NOTICE OF  
CHANGE

MIL-STD-883E  
NOTICE 3  
5 November 1999

DEPARTMENT OF DEFENSE  
TEST METHOD STANDARD  
MICROCIRCUITS

\* FIGURE 2032-28h. Class H resistor loop nicking and scorching criteria exceptions.

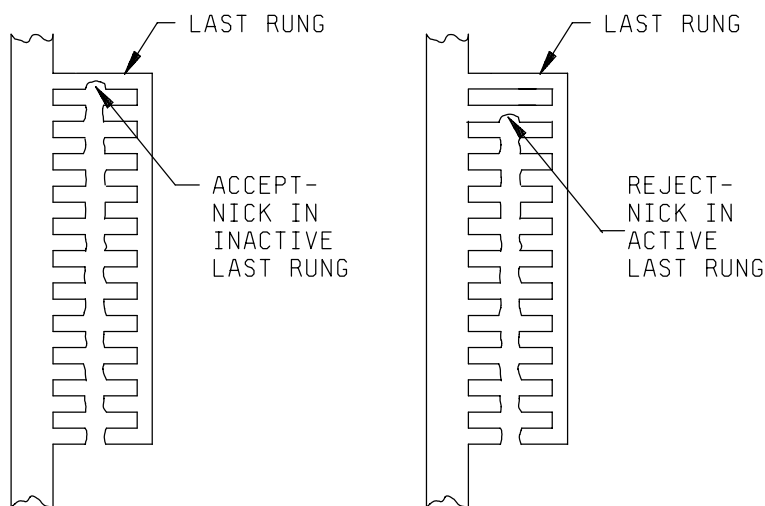
NOTE: This criteria does not apply to the second rung of a resistor loop since the second rung is inactive. This criteria does not apply to a fine loop or to a resistor structure that is comprised of fine loops (see figure 2032-28h).

NOTE: See 3.i.(35) for a definition of coarse and fine resistor loop structures. The element drawing must be referenced to determine if a given resistor loop structure is coarse or fine.
